# Technical Service Information

## CHRYSLER A500/518

### PREMATURE OVERDRIVE CLUTCH FAILURE (SCREEN)

Figure 1

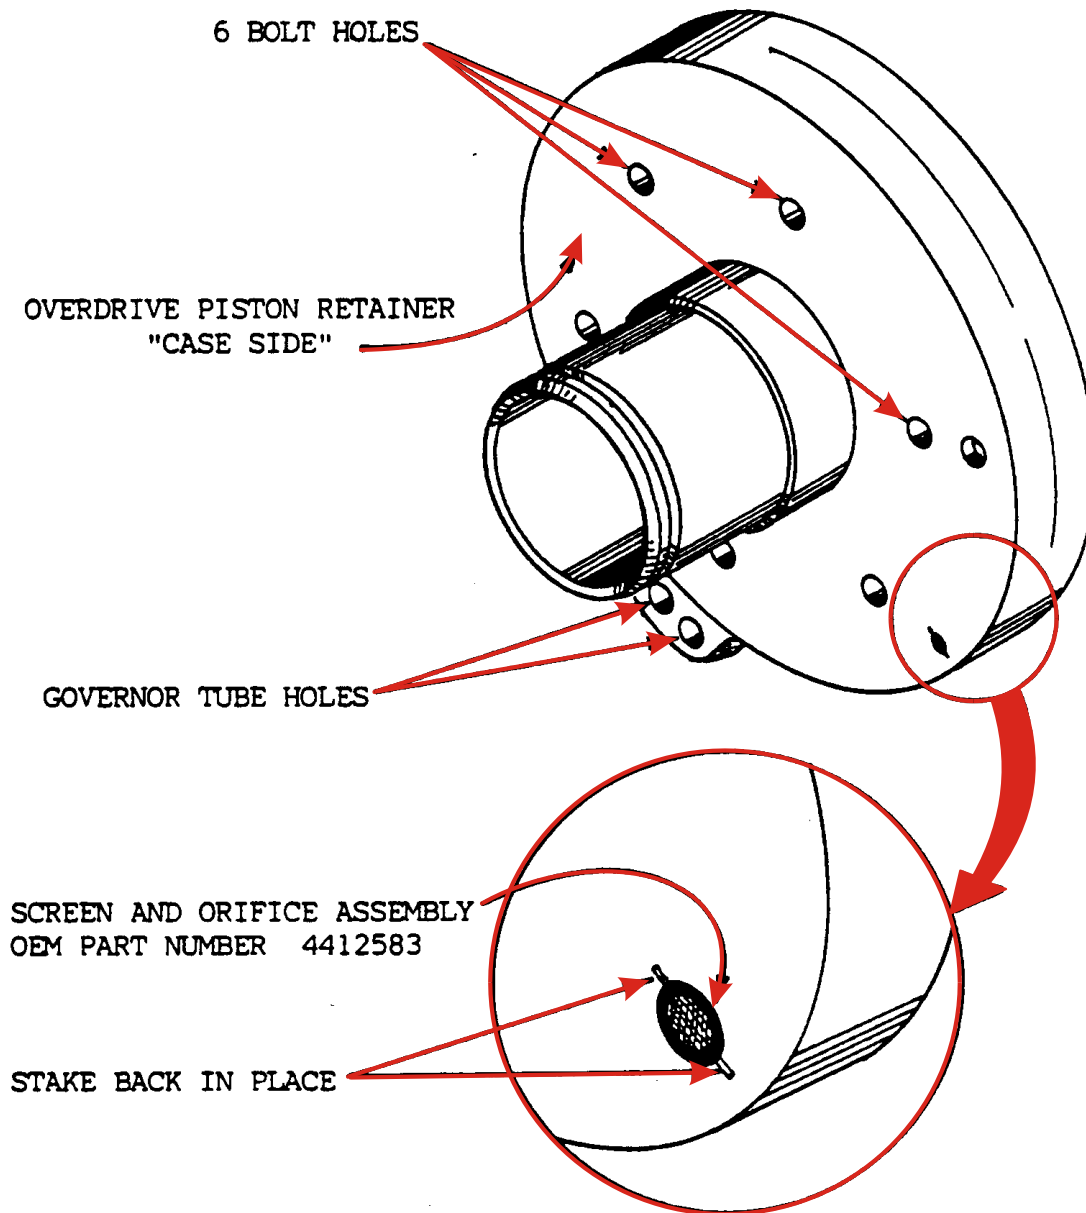
**COMPLAINT:** The overdrive clutches, located in the extension housing, "Wiped Out" at a very low mileage. Early symptoms may be a "Harsh" 3-4 shift, or a "Slipping" 3-4 shift.

**CAUSE:** The cause may be the Screen and Orifice Assembly blown out of the overdrive piston retainer (See Figure 1).

**CORRECTION:** Replace the Screen and Orifice Assembly with a new one, available under OEM part number 4412583, and make sure that you "STAKE" it in place after installation. Refer to Figure 1.

NOTE: This Screen and Orifice Assembly should be checked as a routine procedure, during a normal overhaul to insure that it has been "STAKED" in place. The factory did not start the staking process until March, 1989. "Don't let this one burn you".
